Access Compliance Report

Public Rights-of-Way

Intersection ID: 27530	Main Street: BALLANTYNE_COMMONS_PY	Cross Street: BALLANTYNE_FOREST_DR	Location: SE
ADA ID: 19AC00500E52	Ramp Type: Perp	Initial Pass/Fail: Fail	Overall Compliance: No
Severity Score: 22.5			
Codes/Mitigation Info/Possible Solution		Field Measurements/Component Compliance

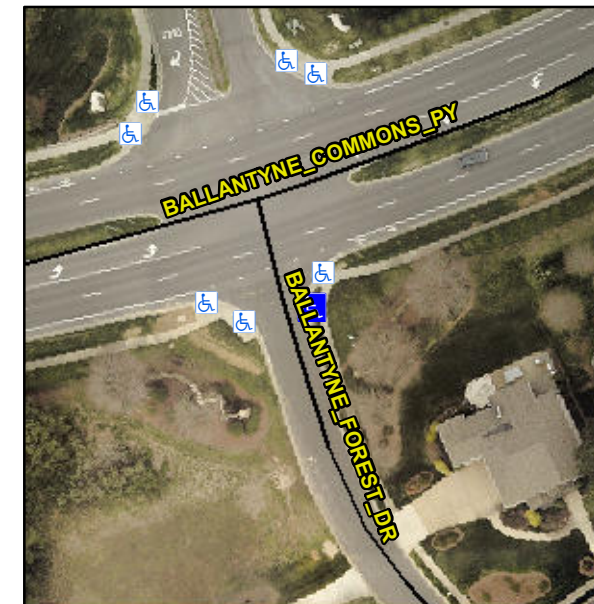
Not Found, R304.5.1, R304.2.2, R304.5.3

Compliance	Description	Data	Compliance	Description	Data
N/A	Ramp Length (in)	50.0	No	Ramp Slope (%)	9.5
No	Ramp Width (in)	47.0	No	Ramp XSlope (%)	3.9
N/A	Flare Type LT	N/A	N/A	Flare Type RT	N/A
N/A	Flare Slope LT (%)	N/A	N/A	Flare Slope RT (%)	N/A
N/A	Flare Traversable LT?	N/A	N/A	Flare Traversable RT?	N/A
N/A	Landing Length (in)	N/A	N/A	DWS Provided?	N/A
N/A	Landing Width (in)	N/A	N/A	DWS Contrast?	N/A
N/A	Landing Slope (%)	N/A	N/A	DWS Length (in)	N/A
N/A	Landing X Slope (%)	N/A	N/A	DWS Full Width?	N/A
N/A	Landing Curb? (Y/N)	N/A	N/A	DWS Offset (in)	N/A
N/A	Shared Landing?	N/A			
N/A	Gutter Ponding?	N/A	N/A	Gutter Slope (%)	N/A
N/A	Gutter Lip Ht (in)	N/A	N/A	Gutter X Slope (%)	N/A
N/A	Painted X Walk1?	No	N/A	Painted X Walk2?	N/A
	X Walk 1 Direction	To W		X Walk 2 Direction	N/A
N/A	X Walk 1 Width (in)	N/A	N/A	X Walk 2 Width (in)	N/A
	X Walk 1 Slope (%)	1.9		X Walk 2 Slope (%)	N/A
	X Walk 1 X Slope (%)	1.4		X Walk 2 X Slope (%)	N/A

Remove & Replace Entire Ramp.
